FIRE SAFETY INSPECTION REPORT

Factory Name: Apex Fashion Wear Limited

Date: 24 November 2018

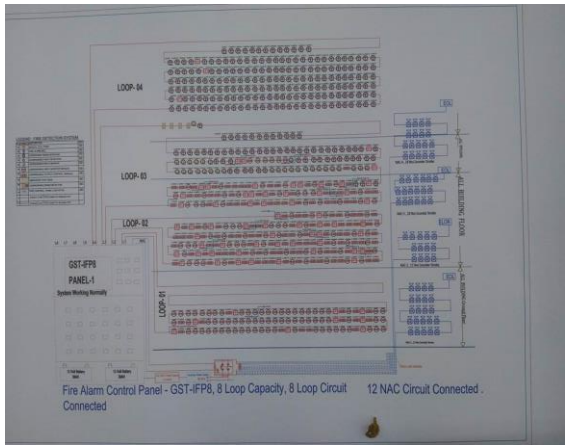
11	Egress	Occupants of store building-8 could find the secondary exit through building-7, but door swing is not to egress travel. Location: All floors of building-8	Modify the door swing to egress travel	Within 01 Month	
----	--------	---	---	------------------------	--

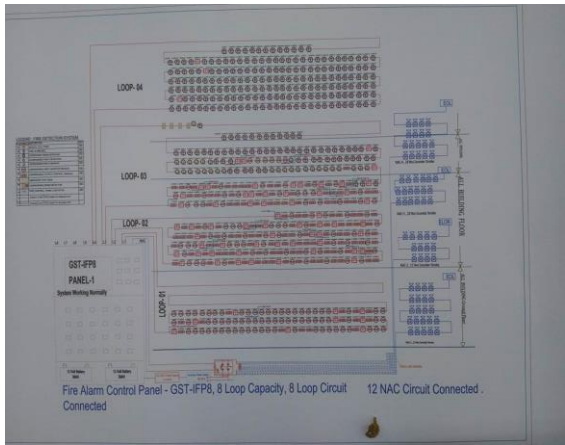
12	Egress	Exits are not remotely located from each other. Due to this reason, travel distance/dead end of aisles/common path of travel is exceeding from the requirements. Building: Shed-6 & 15	Modify exit arrangement or Provide additional exit(s) or Reconfigure the egress arrangement to reduce the maximum common path of travel to not more than 23m or Provide automatic sprinkler system throughout the building as per NFPA 13	Within 01 Month	
----	--------	---	--	------------------------	--
